Lincolnshire and Northamptonshire Breach Hazard mapping

From: Eames, Rob <Rob.Eames@environment-agency.gov.uk>
Sent: 12 November 2018 18:16
To: Burton, Helen
Cc: Kearns, Laura; Farr, Nicola; Cobb, Kirsty
Subject: RE: Proposed Energy Centre Development at South Humber Bank Power Station

**Request for Scoping Opinion - construction and operation of an energy from waste power station with a maximum gross electrical output of 49.9 MW
South Humber Bank Power Station, South Marsh Road, Stallingborough, Grimsby**

RE: Application Number: DM/0575/18/SCO - South Humber Bank Power Station South Marsh Road
Stallingborough Grimsby North East Lincolnshire DN41 8BZ

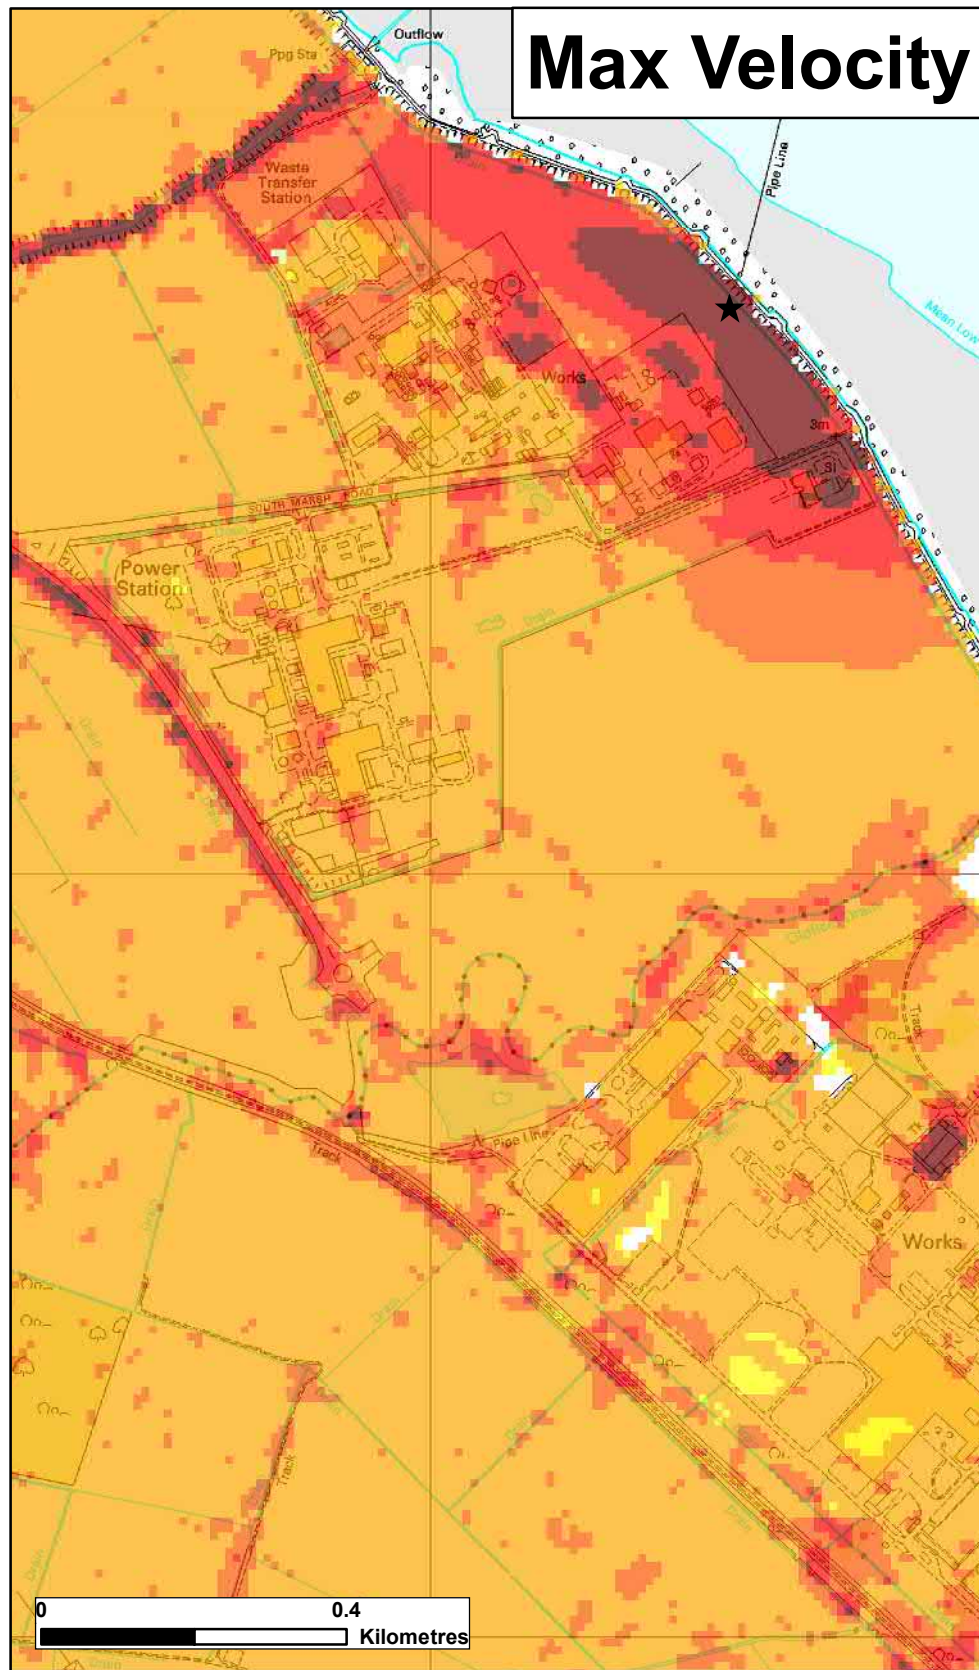
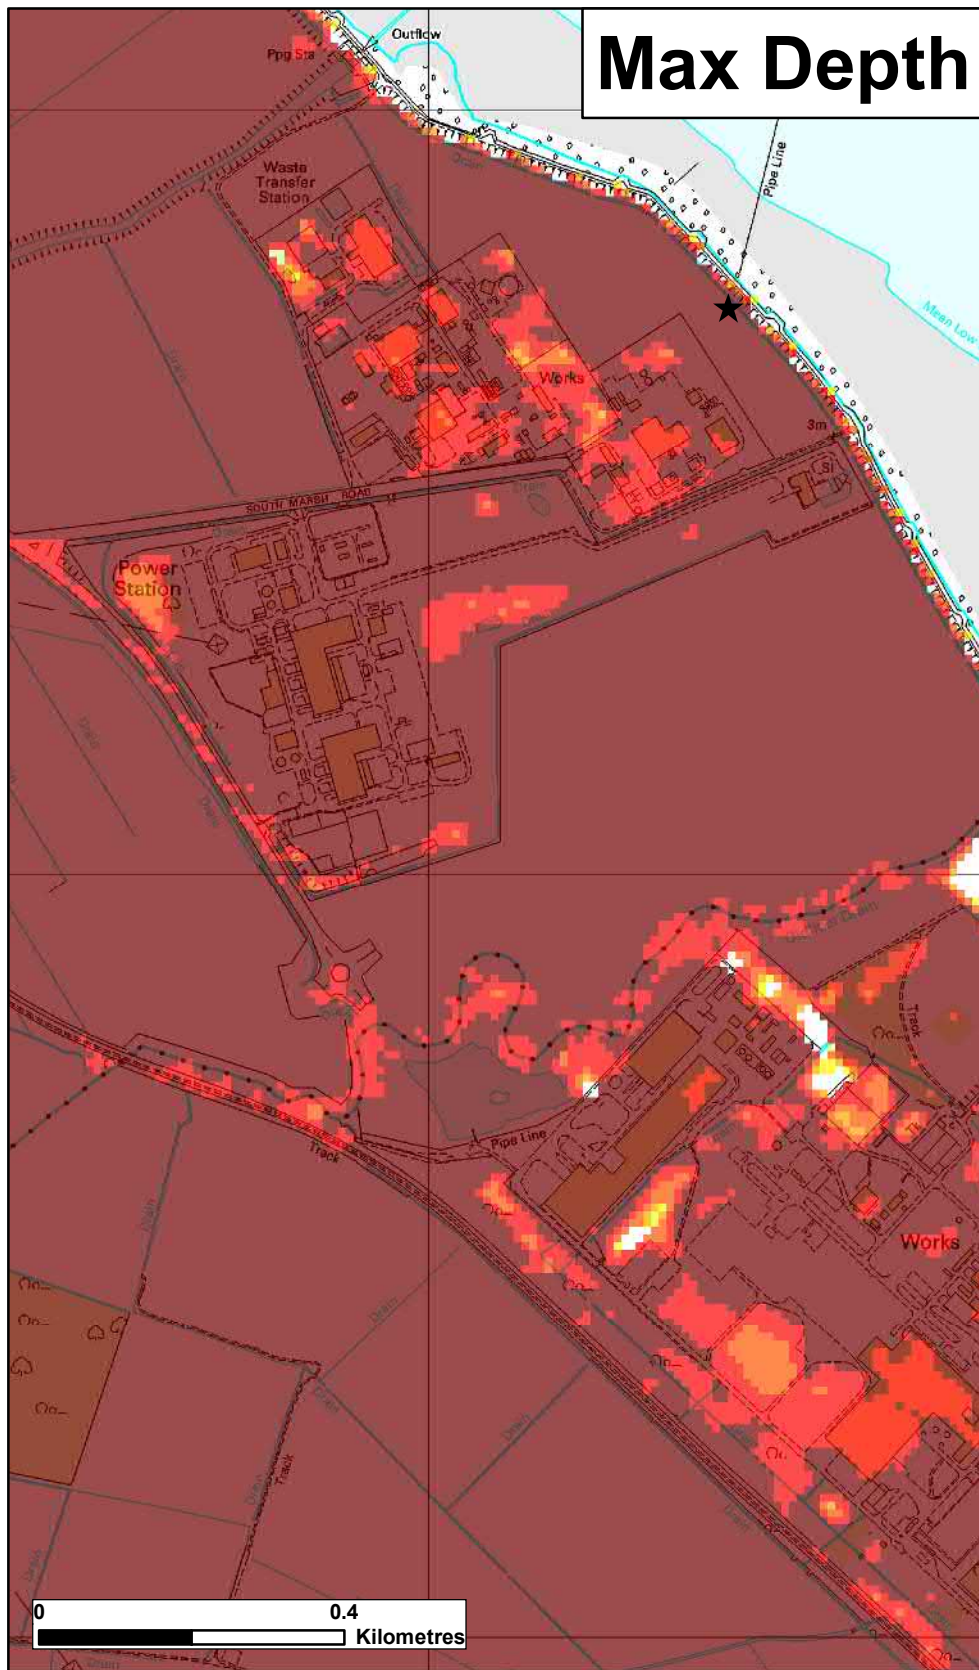
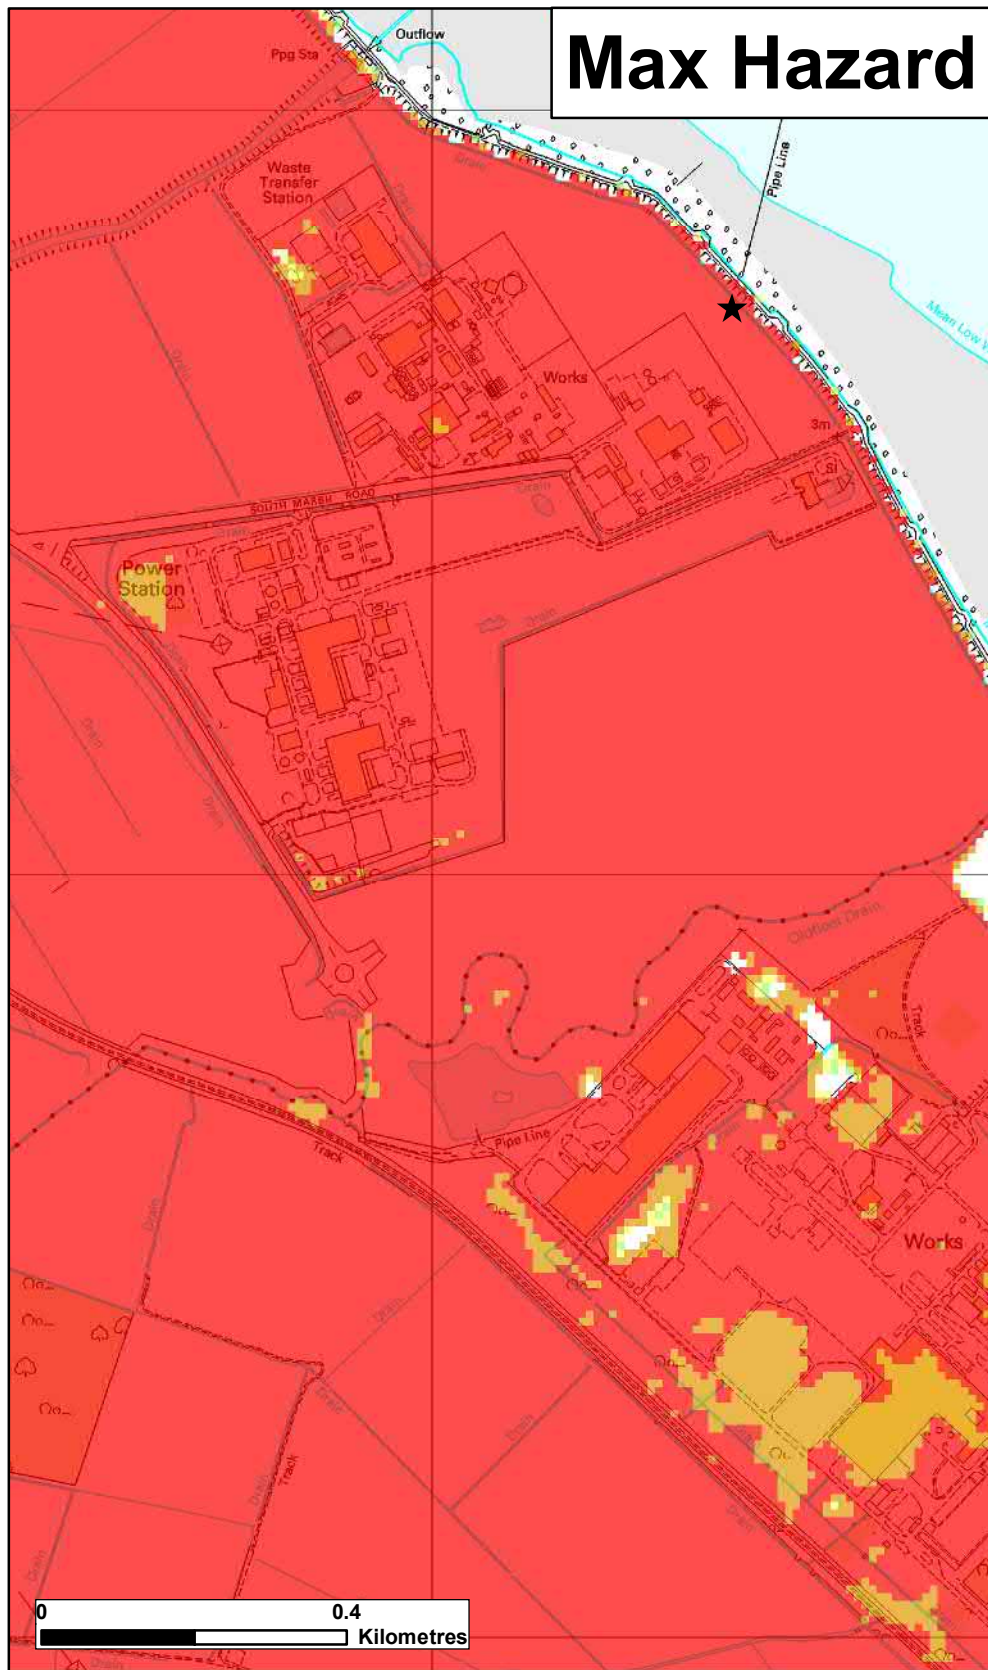
Many thanks for providing the additional information and maps below. The difficulty with providing only depth bands in meters (m) is that if we apply those above varying LiDAR ground levels (GL), we cannot accurately define a consistent minimum level in meters Above Ordnance Datum (mAOD) above which the critical equipment and designated place of refuge at the site should be elevated to be considered safe in the unlikely event of a defence breach.

For example, see data for the 5 locations highlighted below. If I compare the EA 1m LiDAR against the 0.1% AEP to 2115 depth bands provided, this results in a large range in potential water levels (WL) (approx. 800 mm). I understand that the peak water level may vary slightly across a large area where the land exhibits a gradient, but the wider area is relatively flat so we would not expect such a large variance in ponded WLs behind defences. Even if we include a freeboard to account for the uncertainty (usually up to 300 mm requested by the EA), it leaves it widely open to interpretation as to which value to choose to apply that to, and being overly conservative may significantly increase costs to the developer.

It is my understanding that any hydraulic model that produces an ASCII grid of depth results across the flood extent should also produce an ASCII grid of coincident WL/stage results in mAOD units, as it is from that which the model calculated the depths from above the ground terrain model that was used in the model geometry. If the EA do possess the breach model output ASCII grids with mAOD units, would it be possible for these to be provided across the site and local vicinity either in ASCII format via your 'Sharefile' facility, or in a plan illustrating the WLs in a grid of spot points across the site? From this we are intending to identify the highest WL in the areas proposed for development above which to recommend the equipment/safe place of refuge are elevated above. We usually receive this sort of information from other EA areas as part of a Product 6/8 data request.

If it is not possible to provide this, would the EA be able to recommend how we reconcile the large margin of potential inaccuracy incurred from the depth bands in relation to the widely varying GLs in the site boundary (1.9 to 3.7 mAOD) to determine the necessary recommendation?

As the modelling shows that the depths are significantly greater than the 1.6m (+) maximum banding I have attached two breach depth maps – one for the 2115 0.5% (1 in 200) scenario and one for the 2115 0.1% (1 in 1000) scenario. I have reduced the bandings to 250mm and increased the number for the upper depths to cover the depths we discussed. I can't give you a definitive answer for depth but the maps will give you an idea of what the modelling has highlighted.

Unfortunately I'm not able to easily give you depths in mAOD. The breach hazard mapping is created without specific land levels being referenced in mAOD as the accuracy of this information is subject to change. You can however reference against the latest LIDAR available [here](#).
